Project	IEEE 802.16 Broadband Wireless Access Working Group < <a href="http://ieee802.org/16">http://ieee802.org/16</a> >	
Title	LDPC coding for OFDMA PHY	
Date Submitted	2004-08-24	
Source(s)	Brian Classon Yufei Blankenship Motorola	brian.classon@motorola.com yufei.blankenship@motorola.com
Re:	IEEE P802.16-REVe/D4-2004, ballot #14c	
Abstract	This contribution provides the LDPC code used to generate the plots contained in contribution 372. The LDPC code is an updated version of the Motorola code provided in contribution 278r1.	
Purpose	Complete the LDPC specification text.	
Notice	This document has been prepared to assist IEEE 802.16. It is offered as a basis for discussion and is not binding on the contributing individual(s) or organization(s). The material in this document is subject to change in form and content after further study. The contributor(s) reserve(s) the right to add, amend or withdraw material contained herein.

### Recommended Text Changes:

Add/Modify the following text to 802.16e\_D4, adjusting the numbering as required:

**Fig. 2 Block diagram of the encoder architecture for the block LDPC code.**

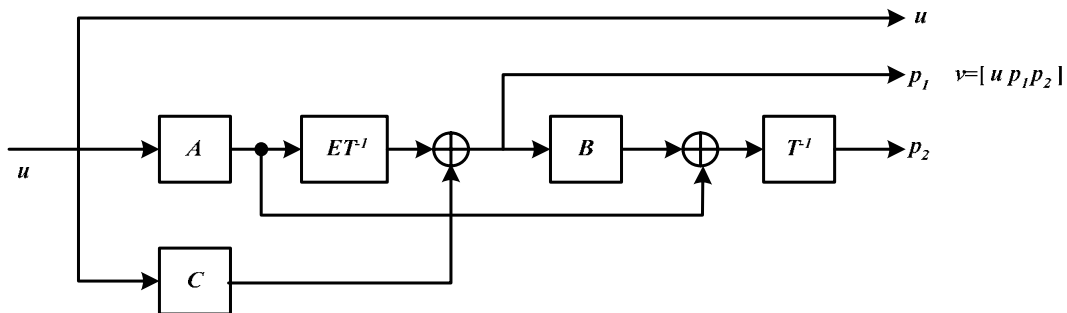
As a result, the encoding procedures and the corresponding operations can be summarized below and illustrated in Fig. 1.

**Encoding procedure**

**Step 1)** Compute  $Au^T$  and  $Cu^T$ .

**Step 2)** Compute  $ET^{-1}(Au^T)$ .

**Step 3)** Compute  $p_1^T$  by  $p_1^T = ET^{-1}(Au^T) + Cu^T$ .

**Step 4)** Compute  $p_2^T$  by  $Tp_2^T = Au^T + Bp_1^T$ .
